Recall Campaign Bulletin

Campaign No. 2024010011, July 2024

Revision C: 09/03/2024

Replace Fuel Pump Delivery Module – Wave 4

Figure 4 (remove electric lines from routing clip)

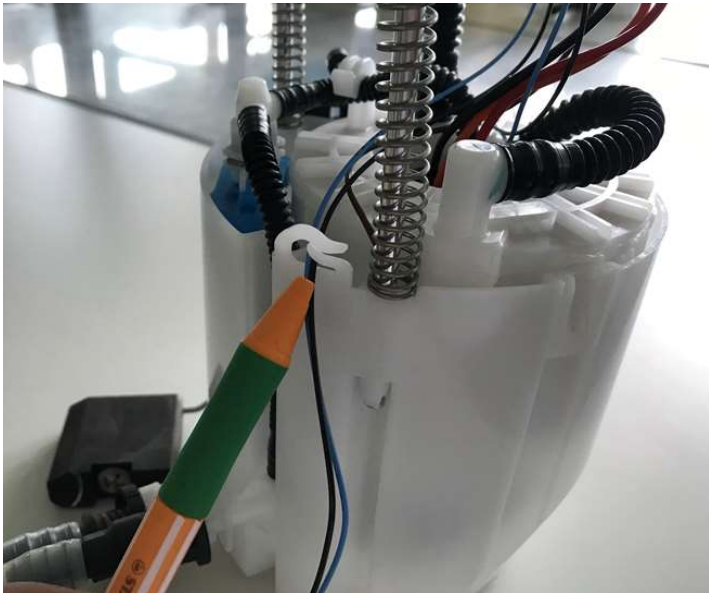
i Delivery modules that are delivered **without float-and-lever sensor** must be modified. (**Figure 4-7**)
